Safety of Gas Transmission and Gathering Pipelines

Docket: PHMSA - 2011 – 0023

Gas Pipeline Advisory Committee Meeting

March 26 - 28, 2018

Effect of changing CVN on PFP of crack in Pipe Body
(Class 1/MAOP = 973)

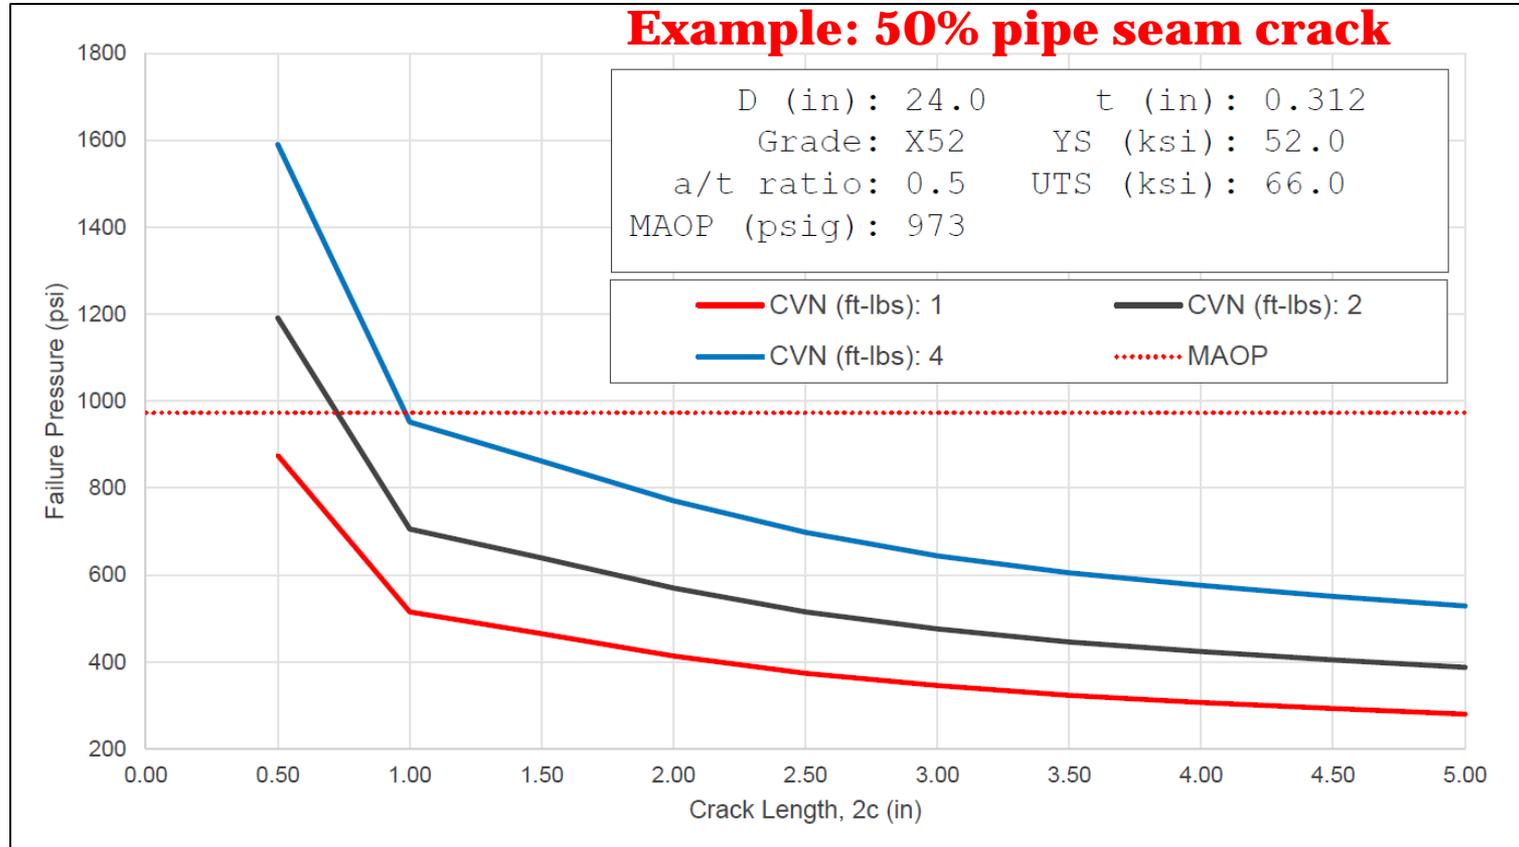
- **Public Comments on fracture mechanics methodology (Dec 2017). Industry representatives on the committee agreed.**
- Industry commented that default Charpy values proposed by PHMSA are too conservative and suggested using 13 ft-lb (body) and 4 ft-lb (seam).
 - **PHMSA: (cont.)**
 - Operators must use known values or values obtained through pipe properties testing whenever available, and would only use default values if actual values are unknown.
 - Example calculations illustrating the effect of raising the default Charpy values on predicted failure pressure are shown on the next 4 slides.

Why does PHMSA propose 1ft-lb for pipe seam?

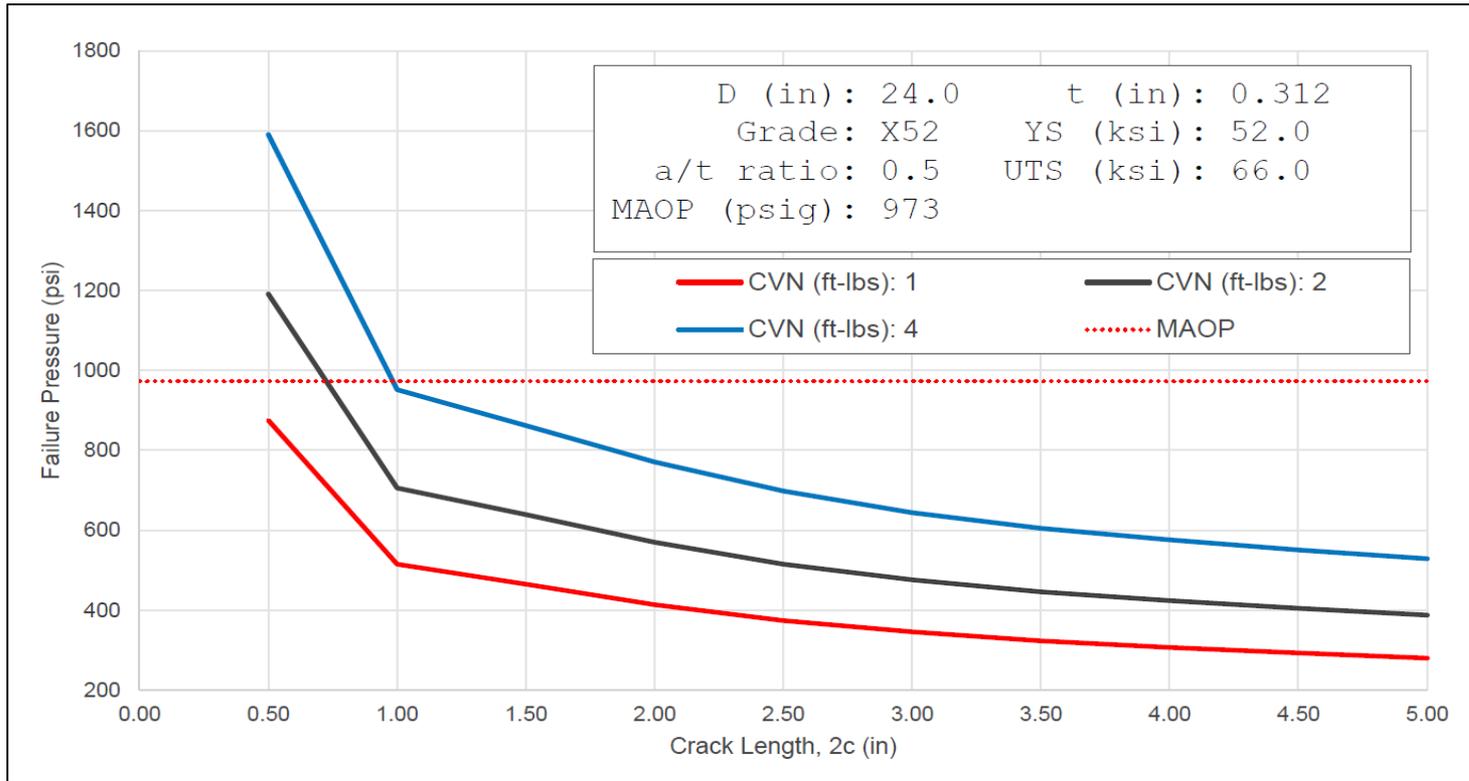
- **Public Comments on fracture mechanics methodology (Dec 2017). Industry representatives on the committee agreed.**
- Industry commented that default Charpy values proposed by PHMSA are too conservative and suggested using 13 ft-lb (body) and 4 ft-lb (seam).
- **PHMSA: (cont.)**
 - Weibull probability distribution curves developed in the INGAA statistical study show the effect of small differences in assumed Charpy toughness on statistical confidence in predicted failure pressure, as illustrated on the next slide.

Effect of changing CVN on PFP of crack in Pipe Seam
 (Class 3/MAOP = 676 psig)

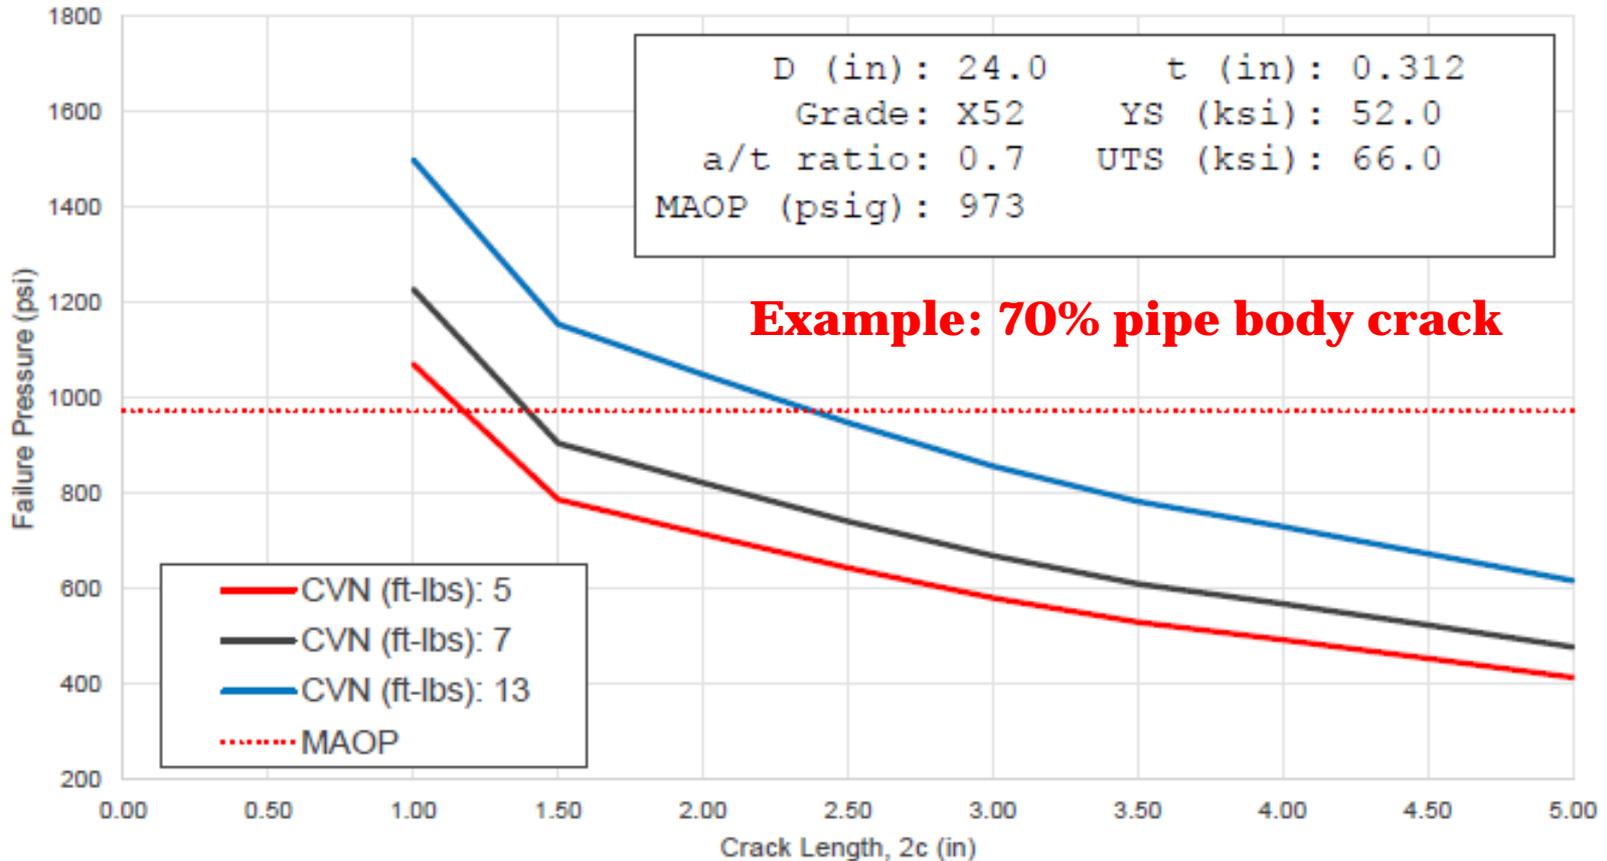
- **Public/Committee Comments on Repair Criteria (3/2/18):**
- Industry commented that PHMSA's proposed criteria for immediate repair of crack defects was too conservative and suggested 70% crack depth or predicted failure pressure of less than 1.1 x MAOP.
- **PHMSA:** based the proposed immediate repair criteria for cracks on successful application of comparable criteria in special permits.
- PHMSA believes 70% and 1.1 x MAOP do not provide an adequate safety margin.
 - ILI tools for detection of cracks do not have the precision needed to allow through wall cracks slightly < 70% or a calculated PFP slightly > 1.1 x MAOP to be treated as 1-yr (HCA)/2-yr (non-HCA) conditions.
 - Cracks can grow very rapidly.
 - Material properties can have a dramatic affect on safe pressures, as illustrated on the next slide.

Fig. 4 Timing for Scheduled Responses: Time-Dependent Threats, Prescriptive Integrity Management Plan

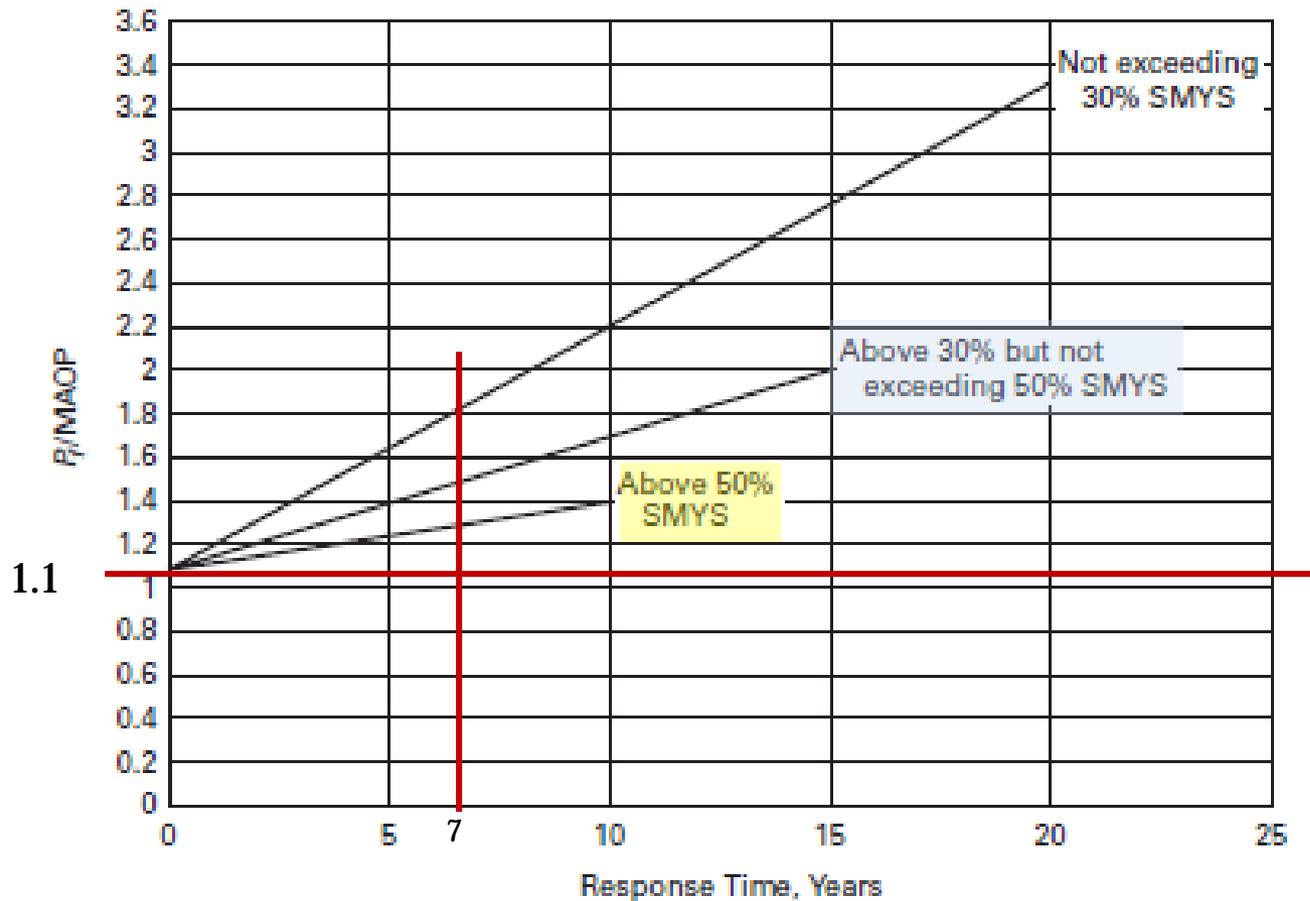
- Use of class location safety factors for 1-yr (HCA) and 2-yr (non-HCA) repair criteria is inconsistent with ASME B31.8S, Figure 4.
- **PHMSA:** (cont.) By not repairing anomalies until they grow to critical dimensions for an immediate condition, many anomalies could grow until they use up much of the safety margin and become immediate conditions.
- PHMSA believes this is a contributing factor in explaining why the immediate repair rate has not dropped after completion of baseline assessments - scheduled conditions are allowed to grow until they become an immediate condition.
- This is illustrated on the slides that follow.

- Use of class location safety factors for 1-yr (HCA) and 2-yr (non-HCA) repair criteria is inconsistent with ASME B31.8S, Figure 4.
- **PHMSA:** PHMSA's goal is to reduce the rate of immediate repair conditions. PHMSA suggests replacing reliance on Figure 4 with the class location based safety factors for one-year conditions (HCAs) and two-year conditions (non-HCAs).
- B31.8S, Section 7, Figure 4, allows operators to not repair scheduled anomalies until the defect has grown to the level of an immediate indication. *“Indications in the scheduled group are suitable for continued operation without immediate response provided they do not grow to critical dimensions prior to the scheduled response.”* (cont.)

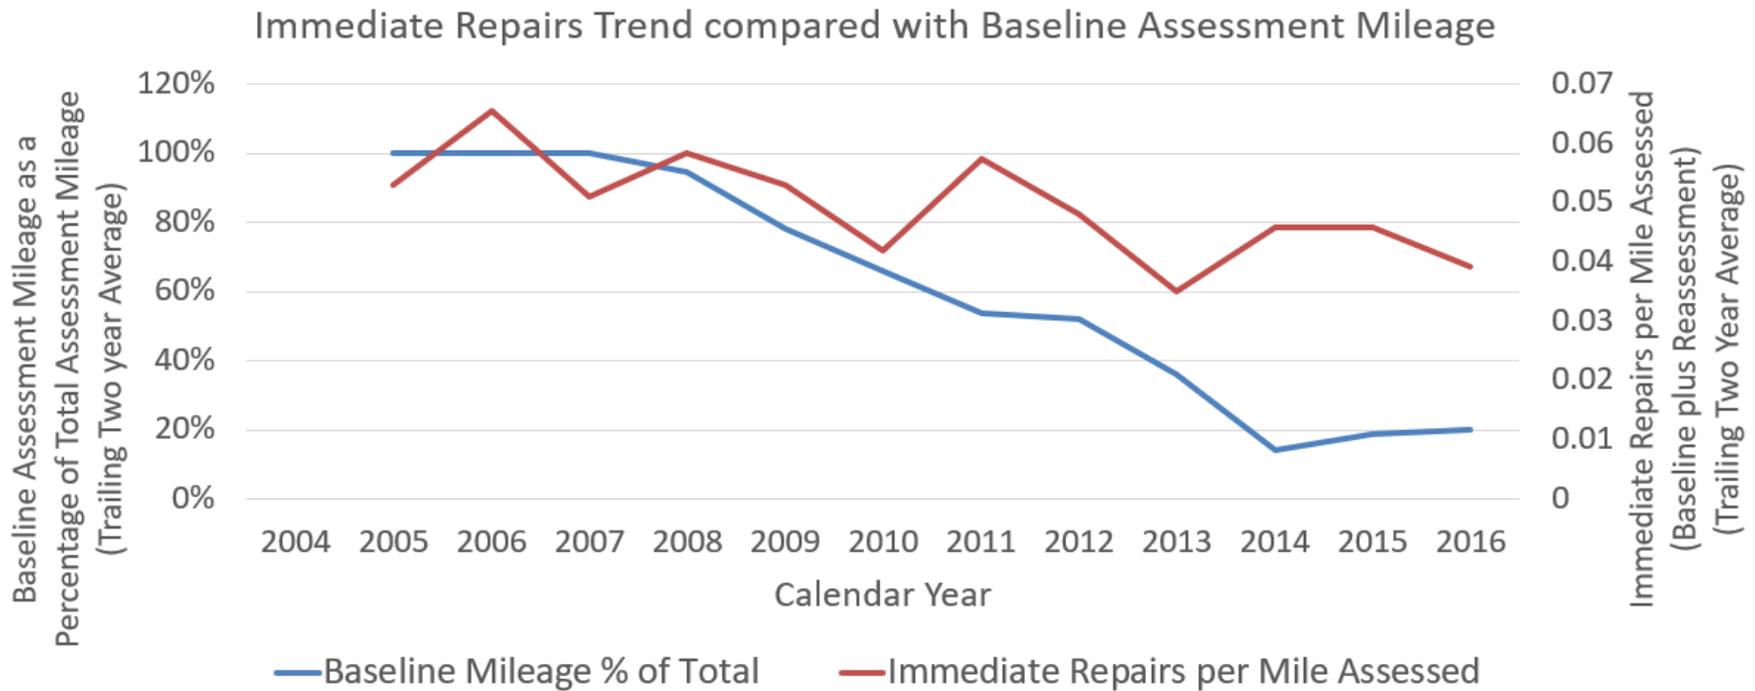
- **PHMSA** has also noted that the trend in immediate repairs (red) has not decreased commensurate with the conclusion of the baseline assessments (blue) at the end of 2012.
